November 18, 2024

Subject: State Farm Insurance Building  
Structural Assessment Letter

Project Address: 4815 Main Street  
Yorba Linda, CA

**Photo #5: East Exterior Wall Water Damage**

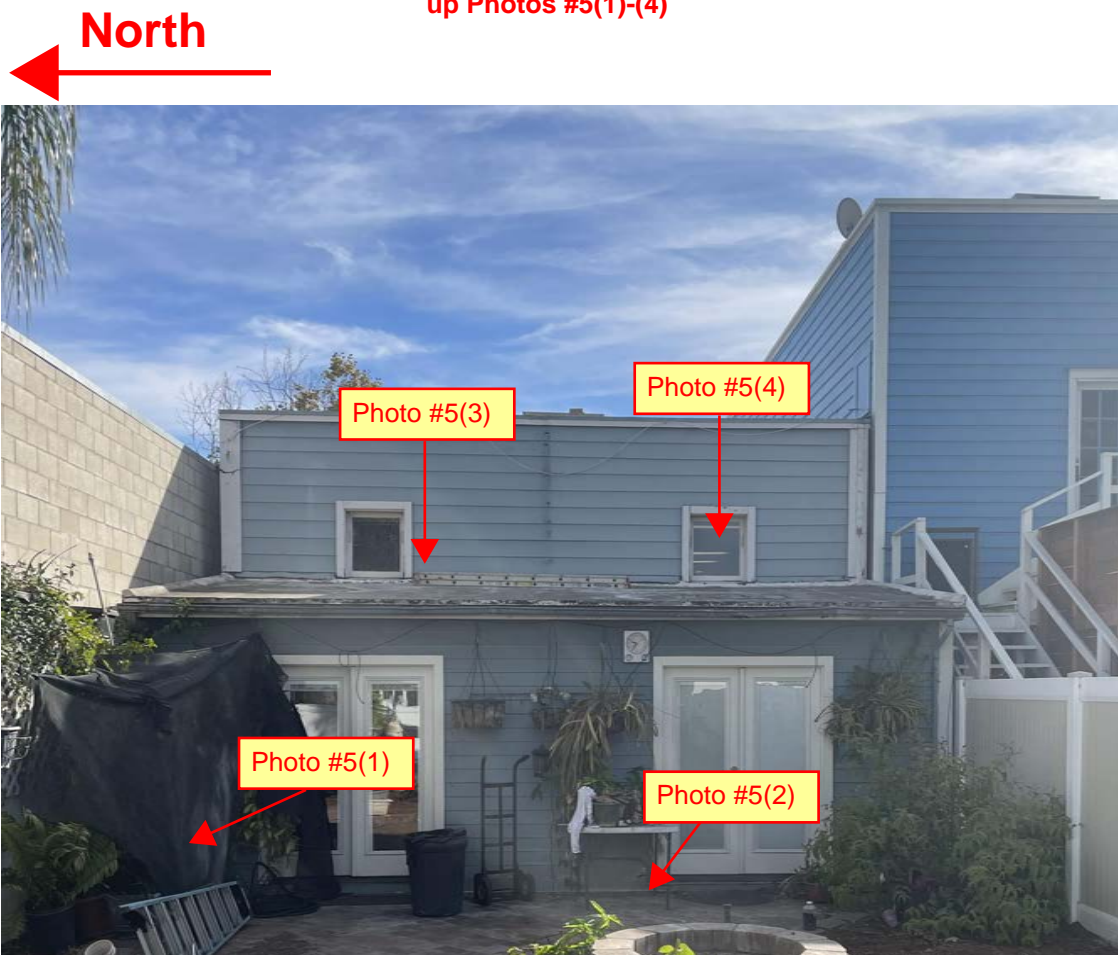
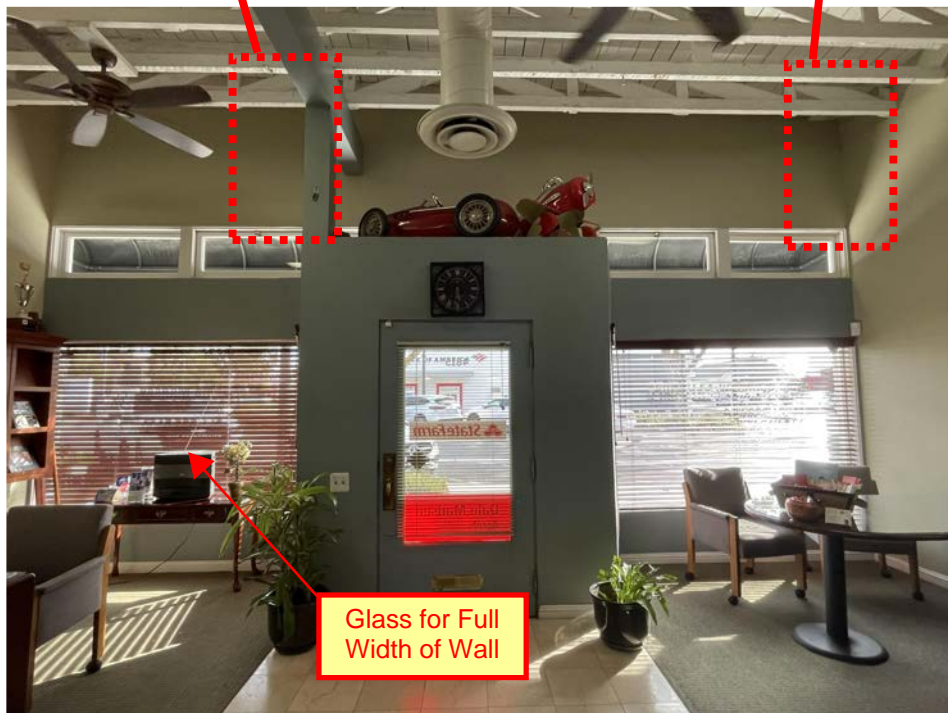
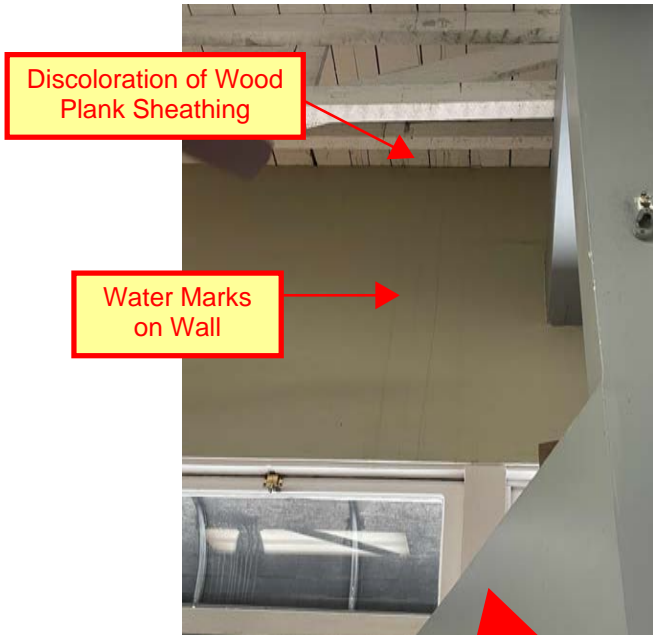
- Visual review of the north and south wall exterior siding was limited due to the close proximity of the adjacent buildings.
- Water damage and dry rot of the west exterior wall was observed. See attached **Photo #5**.

- The east and west exterior walls provide lateral bracing for north/south direction loading.
  - The west wood plank siding shearwall would not comply with the 2022 CBC detailing and strength requirements; however, it does provide nominal seismic load resistance. The wall anchorage to foundation was not visible for review. See **Photo #5** for west wall elevation.

**Photo #6: Water Leaks (East Wall)**

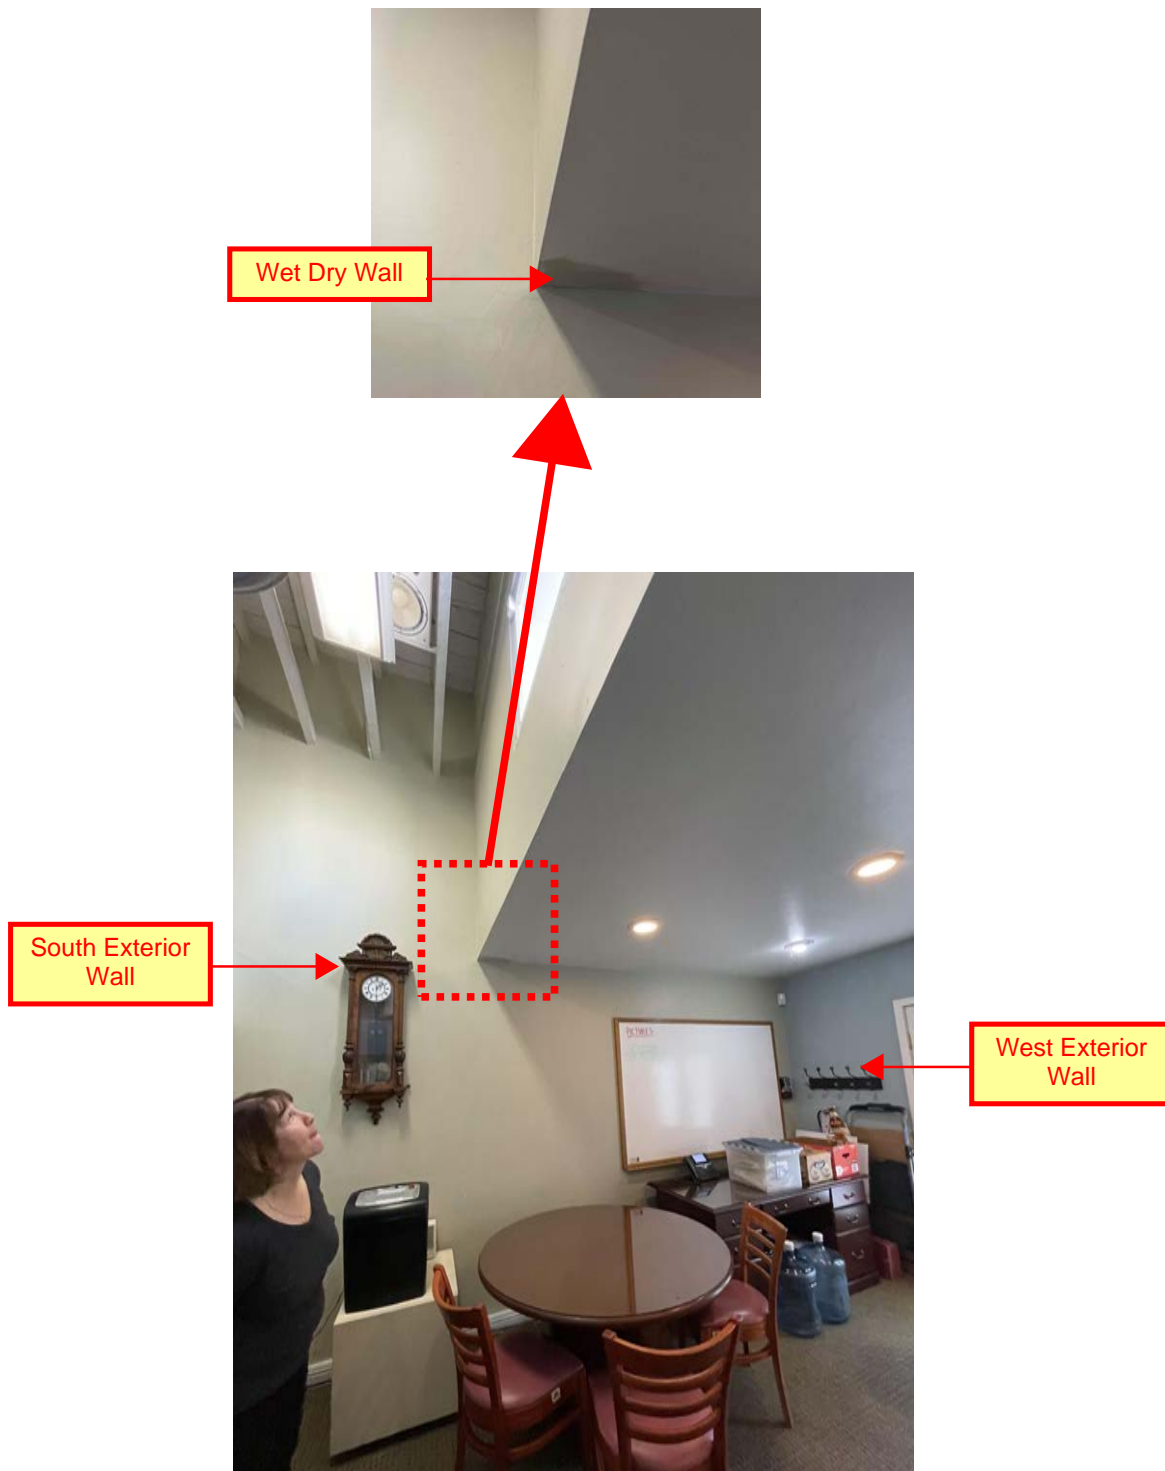
- Water leaks were observed at multiple locations along the inside face of the exterior walls. See attached **Photo #6** and **Photo #7**.
- The north and south exterior walls are exposed to weather without ability to maintain their condition due to the close proximity of the adjacent buildings. There appears to be flaking of the paint and/or wood siding. See attached **Photo #8**.

Photo #9: East Wall with No Lateral System

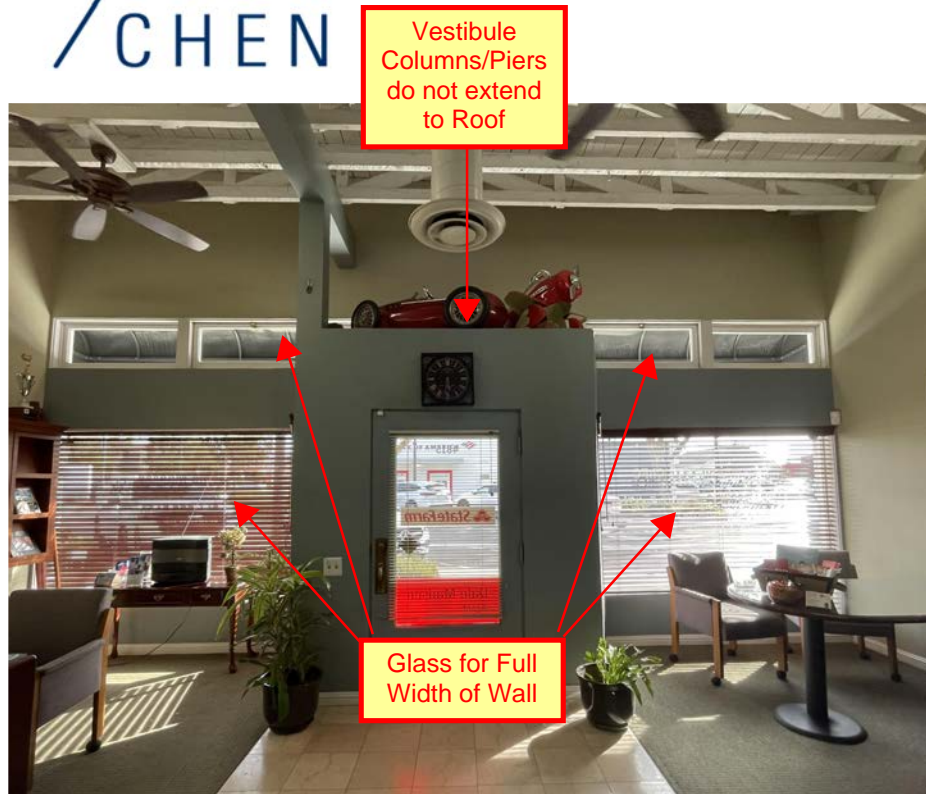
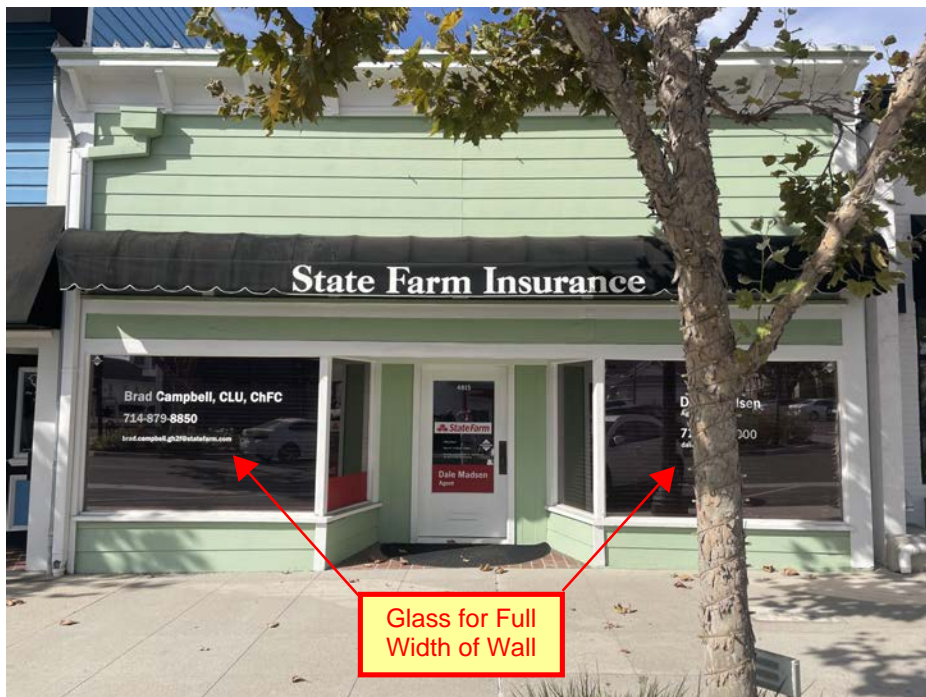
- The east exterior wall has no visible lateral load resisting system. There is glass for the full width of the wall for the lower half of the wall elevation. See **Photo #10** for east wall elevation. **This is consistent with intent of ASCE7-16 Table 12.3-2 1B & 5B soft story and weak story vertical irregularities which are not permitted in areas of high seismicity.**

- Concrete Masonry Unit (CMU) exterior walls at the north, south and west faces. CMU wall construction will be more durable and weather resistance which is necessary due to the inability to maintain the walls adjacent to the neighboring buildings. CMU walls will also provide the necessary fire-resistance rating required by the 2022 CBC.
- Provide a steel moment frame at the east face storefront along Main Street. A steel moment frame could be designed to satisfy the strength and stiffness requirements of the 2022 CBC and continue to allow for an open storefront concept. An Architect would be able to design an open storefront with an aesthetic consistent with the original building or time period.

**Photo #11: Structural Separation at Adjacent Buildings**

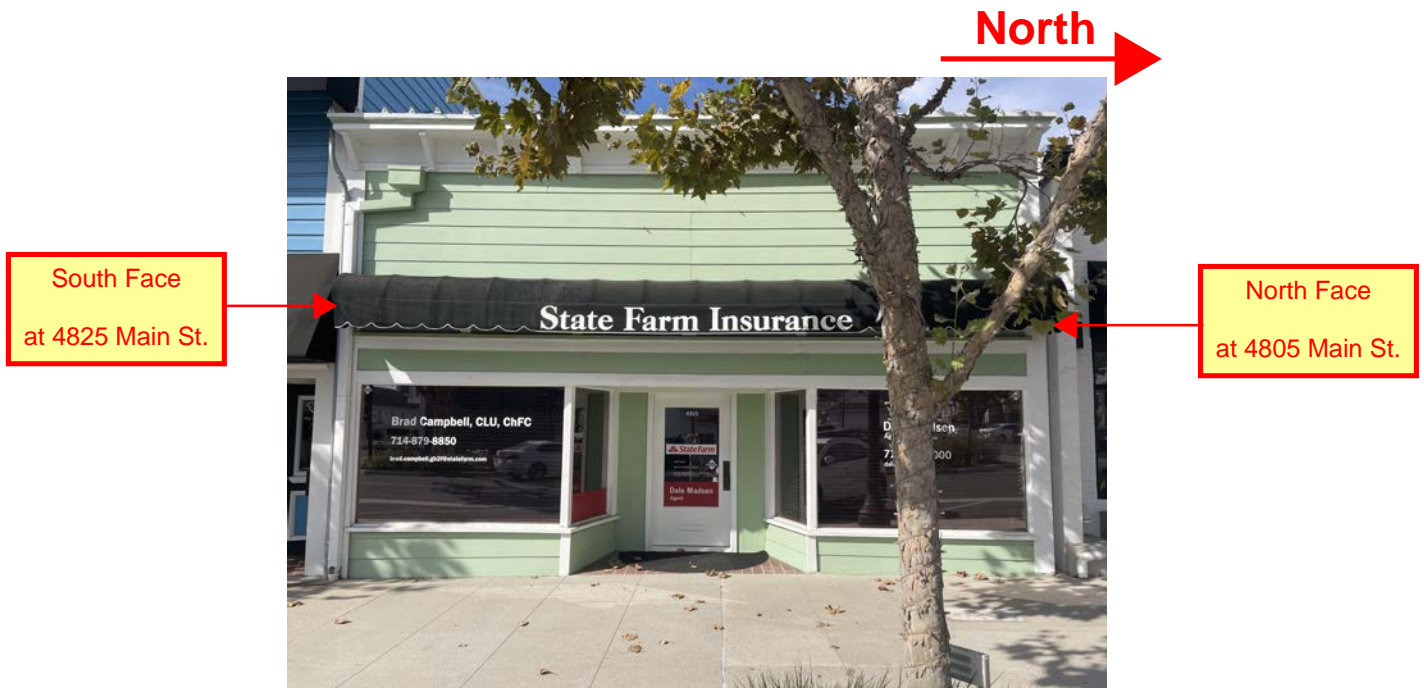
- The structural separation at the north side of the building is approximately 8 inches. See attached **Photo #11**.

- The structural separation at the south side of the building is approximately 1 inch. See attached **Photo #11**.
- **The existing structural separation at the south side of the building does not comply with the requirements of the 2022 CBC. Lack of structural separation could result in pounding between adjacent buildings during a seismic event.**
- Fire-Resistance Rating at Exterior Walls:
  - 2022 California Building Code Table 705.5 requires 1-hour fire-resistance rating for “B” occupancy adjacent to property lines.
  - **The existing exterior wood wall construction does not provide a 1-hour fire-resistance rating as required by the 2022 CBC.**

- The existing structural separation between the south exterior wall of the building and the 4825 Main Street property is small and significantly less than what is required by the 2022 CBC. Pounding between the two buildings is anticipated during a design level seismic event which could lead to significant structural damage of both buildings. The existing structural separation is so small that structural retrofit to stiffen the building would not solve the issue.

- Plywood sheathed roof over wood joists that span between exterior walls. Roof framing would be designed to provide the necessary strength and stiffness to brace the exterior CMU walls for out-of-plane loads.
- Concrete slab on grade with shallow foundations. A concrete slab on grade will have superior strength and stiffness to brace the exterior CMU walls for out-of-plane loads, as opposed to a raised wood floor system.
- Relocate the south exterior wall to the north to provide an adequate structural separation between the 4825 Main Street building as required by the 2022 CBC. The anticipated structural separation would be approximately 6 inches, thus the south wall would need to shift north approximately 5 inches from its current location.
